# **AQUATECH**

## **PARTS BULLETIN**

Photo submitted by Gary Karst, Terex Utilities West

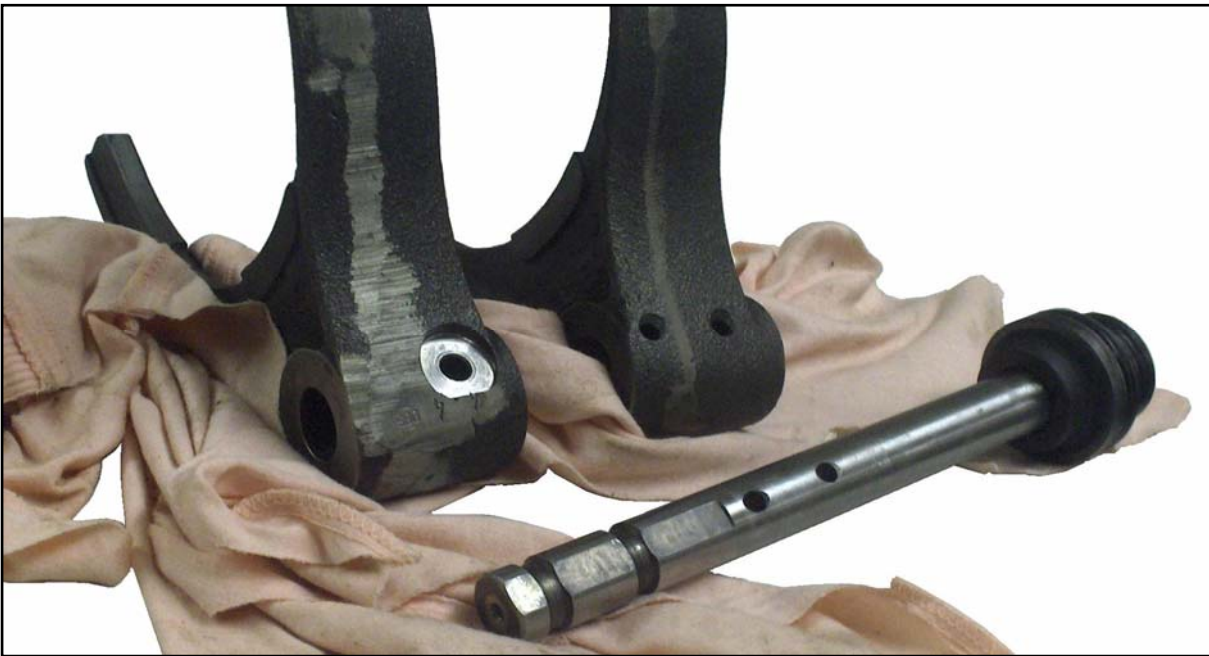
It has come to our attention that there was a running design change back in July of 1998 on the shifter forks on OMSI model PFT-PC2/3000 and PFT-PC4/3000 split shaft PTOs. The Aquatech PTO assembly part numbers affected are 164134, 164135, 164137, 164140 and 164141. The earlier design fork was held in place by roll pins. The current design uses a single bolt and nut. When replacing either the fork or the stem (shifter shaft) on the earlier design - both items will have to be replaced together. Also the newer design bolt and nut will be required. The part numbers involved are listed below.

<b>A164440</b>	<b>Main Fork</b>
<b>A164435</b>	<b>Main Stem</b>
<b>A164402</b>	<b>Nut</b>
<b>A164441</b>	<b>Bolt</b>

<b>A164468</b>	<b>Lateral Fork</b>
<b>A164470</b>	<b>Lateral Stem</b>
<b>A164402</b>	<b>Nut</b>
<b>A164441</b>	<b>Bolt</b>

\* The other assemblies are not affected on the lateral outputs because they have Power Clutch™ clutch packs.
